Docket Items # 6 & # 7
BAR CASE # 2017-00145 &
2017-00146

BAR Meeting
June 7, 2017

ISSUE: Partial Demolition/Capsulation and Alterations

LOCATION: 1605 King Street

LIGHT RAIL TYPE 1 | TYPE 2 | TYPE 3

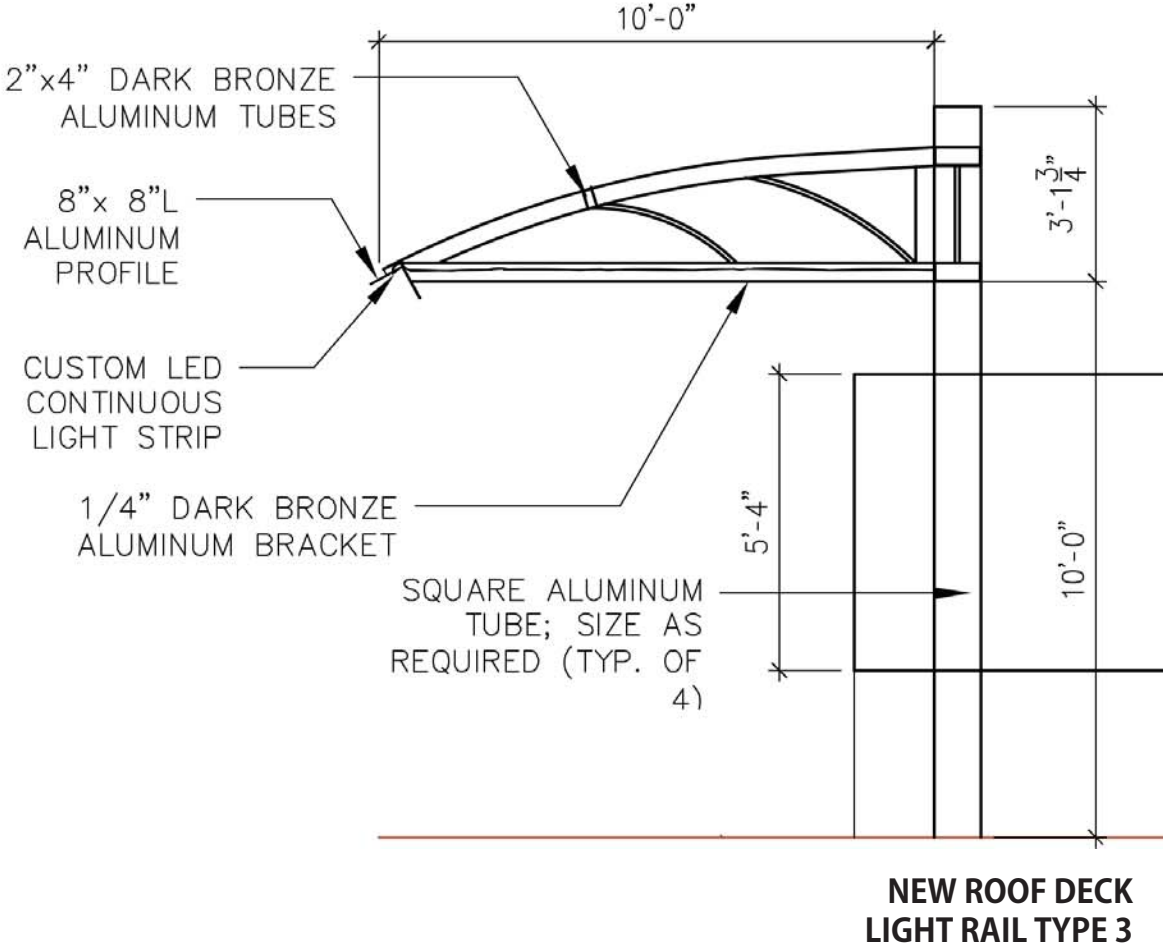
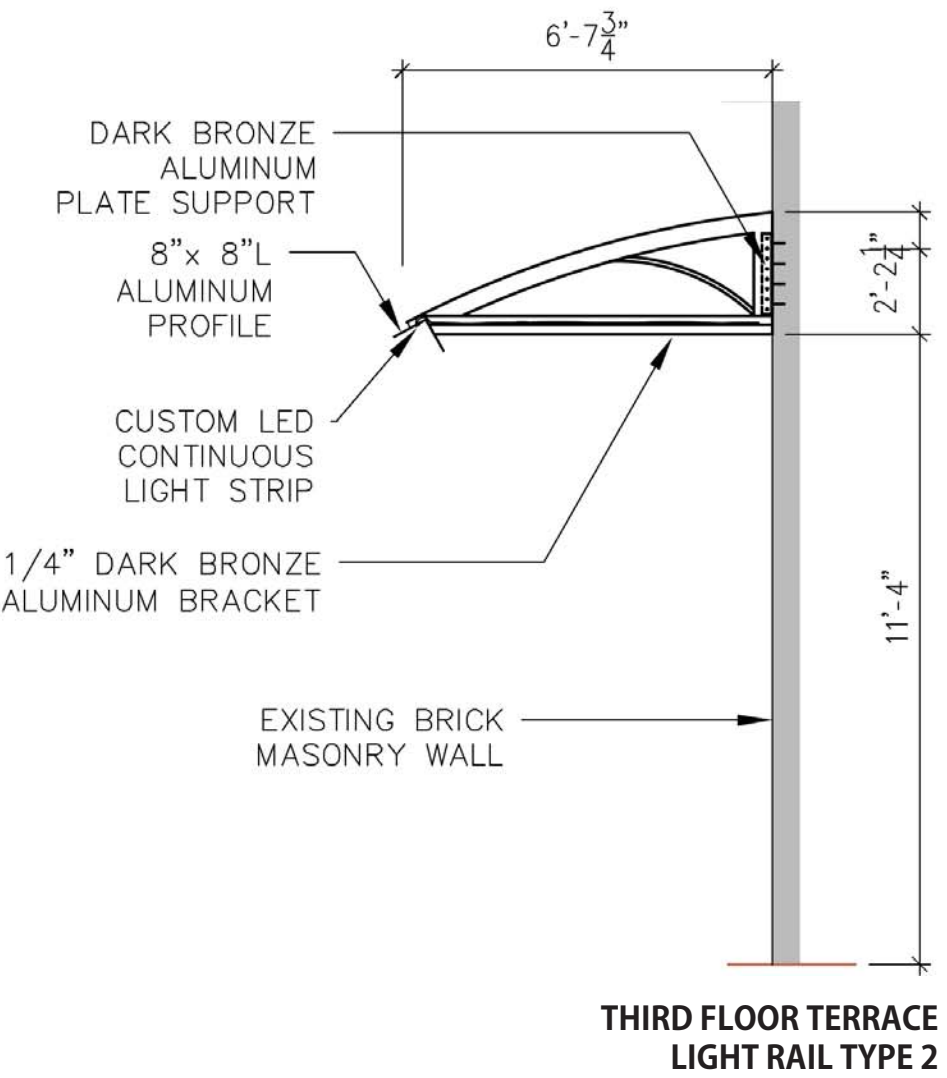
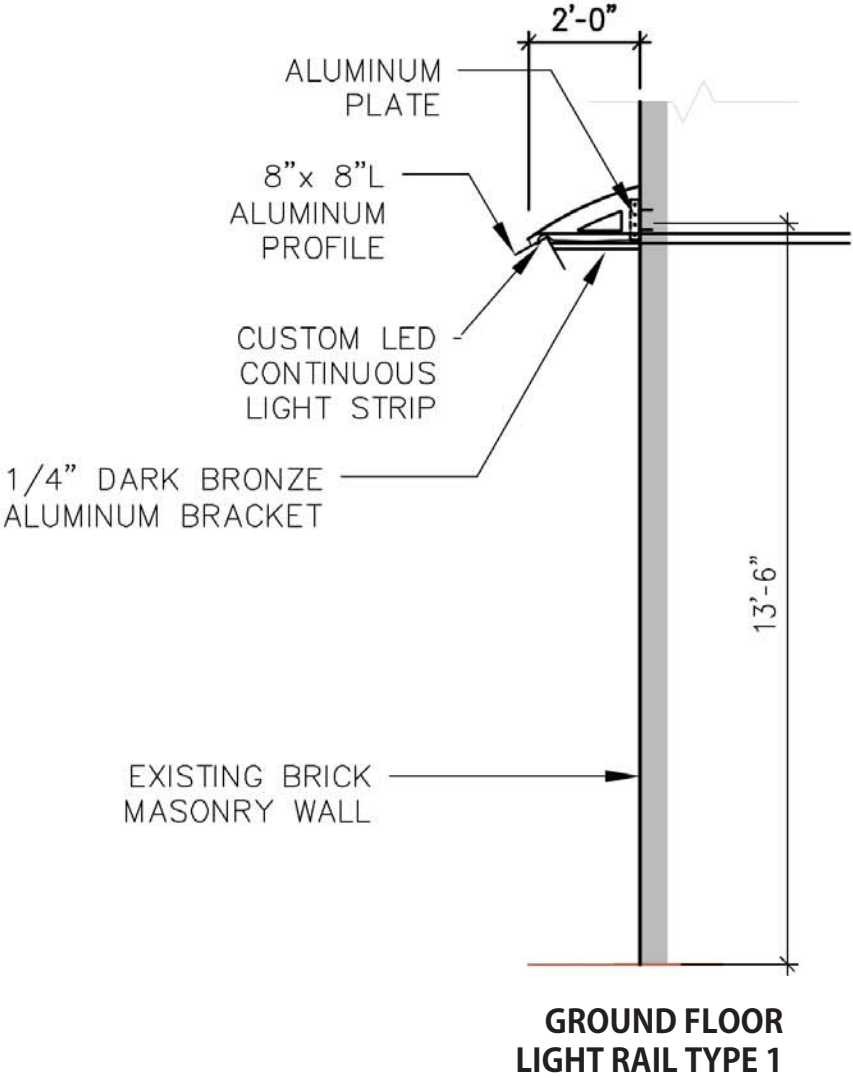
- C-5 Proposed Light Rail Type 3 appears to increase the building height beyond the zone maximum height threshold of 50 feet. Please call out height from the average finished grade on all proposed elevations to show compliance with the 50 foot height maximum.

COMPREHENSIVE SIGNAGE SCHEDULE

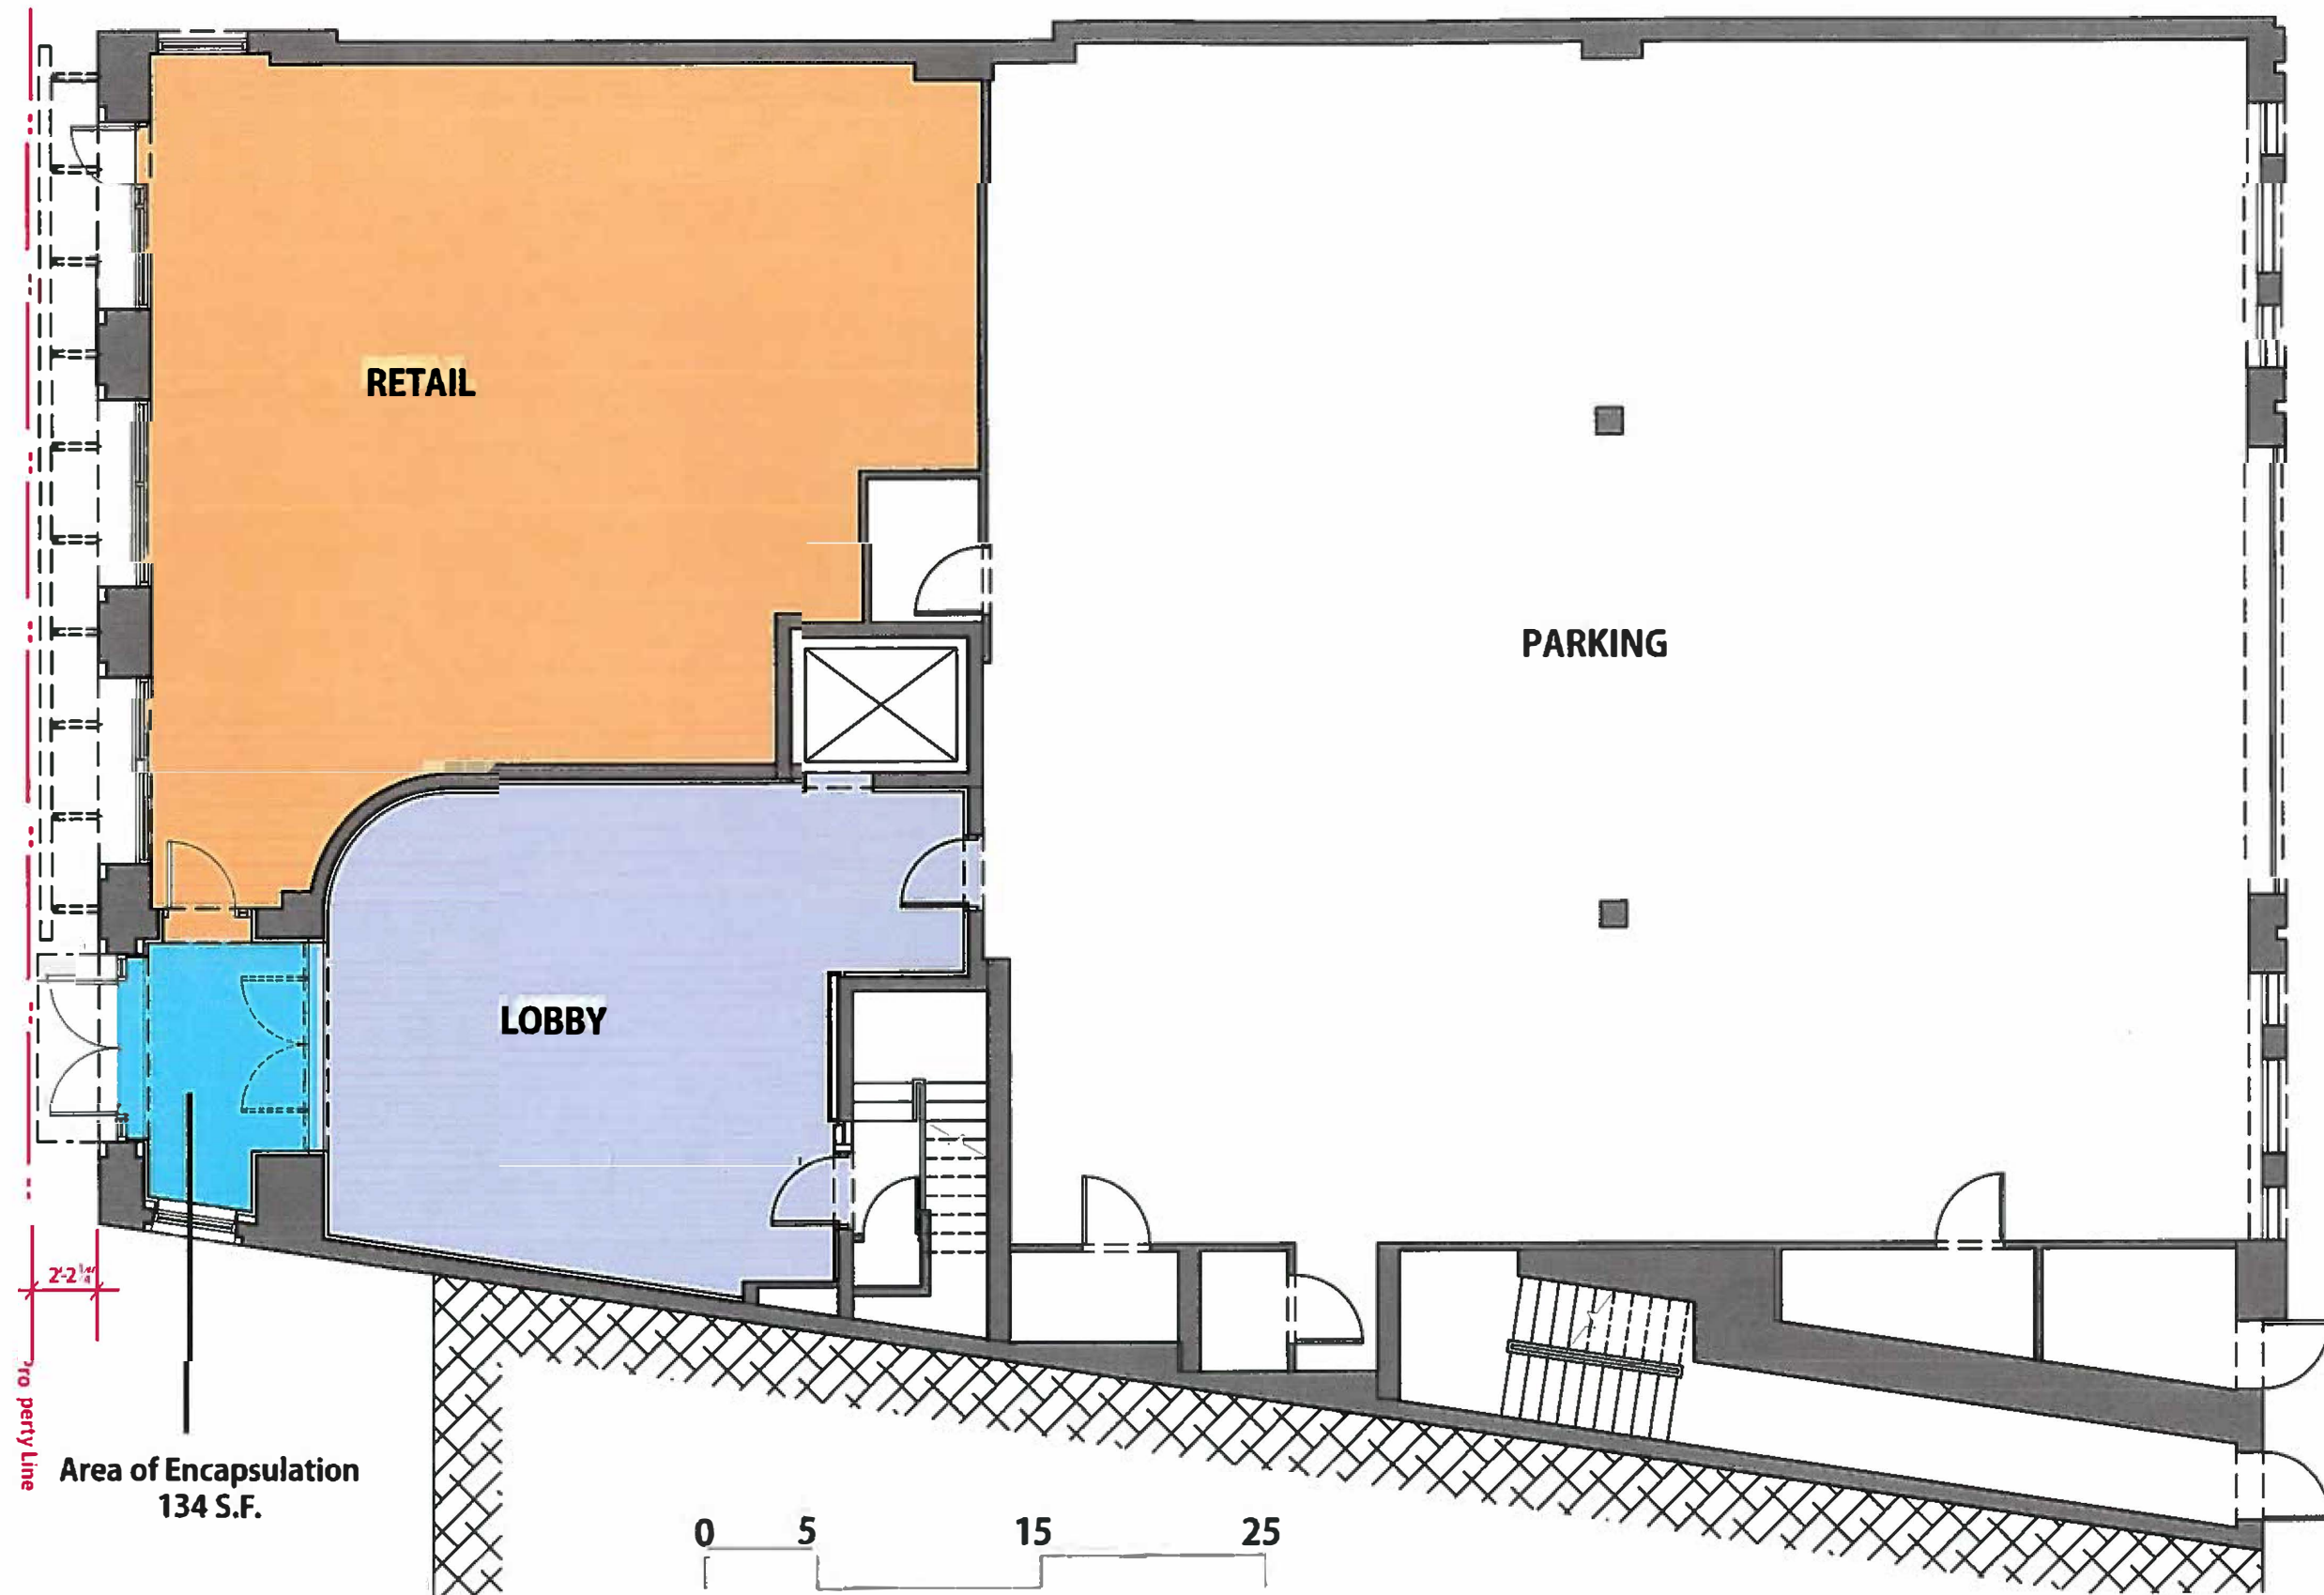
1. No internal illumination of signage is permitted. Halo illumination or targeted mini-spotlights for the two wall signs and hanging sign may be approved by staff as part of the sign permitting process.
2. No pin-mounted letters may be installed through the brick. Should the BAR approve pin-mounted letters, installation specifications showing the use of a silicone adhesive or shop drawings showing the installation location of all letters in the mortar joints must be approved by staff as part of the sign building permit process.

The proposed sign plan includes the following (*see applicant's sheet 19*):

- Three wall signs (each 7 SF) in the first floor store window sign band (Signs A, B and C)
- One wall sign (15 SF) above the entrance (Sign D)
- One hanging sign (6SF) at first floor storefront windows
- One wall sign (36 SF) above second story windows, sign board or pin-mounted letters, with internal illumination (alternate illumination with halo or mini spotlights) (Sign F)
- Three flag signs (each 15SF)

King Street, where this building is located, has many larger commercial buildings with varying approaches to signage. Staff finds that although the applicant is proposing six signs plus three flags at upper levels, the overall approach is generally appropriate for a building this size because no single sign will overwhelm the building. Additionally, the placement of three wall signs (Signs A, B, and C) in the storefront window sign bands will balance the visibility of the retail storefront area. These signs, combined with an optional hanging sign, are in scale with the retail area. The other wall signs, Signs D and F, will serve other tenants of the building and are appropriately located.

The applicant's sign package suggests internally illuminated letters for the wall signs. The sign illumination policy direction from the BAR, provided during consideration of new signs for several Burke & Herbert Bank buildings several years ago, is that internally illuminated box signs or individual can letters are not appropriate in the historic district but that halo illuminated can letters may be appropriate on modern buildings. The BAR stated that only externally illuminated signs are appropriate on historic buildings. Therefore, staff recommends that the only lighting permitted be halo illumination or targeted mini spotlights, to be approved by staff as part of the sign permitting process.

Additionally, the BAR's policy is to discourage pin-mounted individual letters mounted directly into the brick because they cause permanent damage to the bricks, whether historic or modern. However, one applicant recently applied pin-mounted letters with a silicone adhesive which was represented to be reversible and staff believes *may* be an appropriate solution. Alternately, if an applicant can provide a scaled and detailed sign plan and shop drawings showing the exact installation of each individual letter through the mortar joints, staff can support the individual pin mounted letters.

- C-6 Proposed Signage and Flags including Sign A, Sign B, Sign C, Sign D, Sign E, and Sign F and Flags 1-3 comply with zoning. Sign E must also adhere to section 5-2-29 for street encroachments of the Code of Ordinances. Sign F must be located 35 feet below grade to comply with Section 9-104(B)(10).
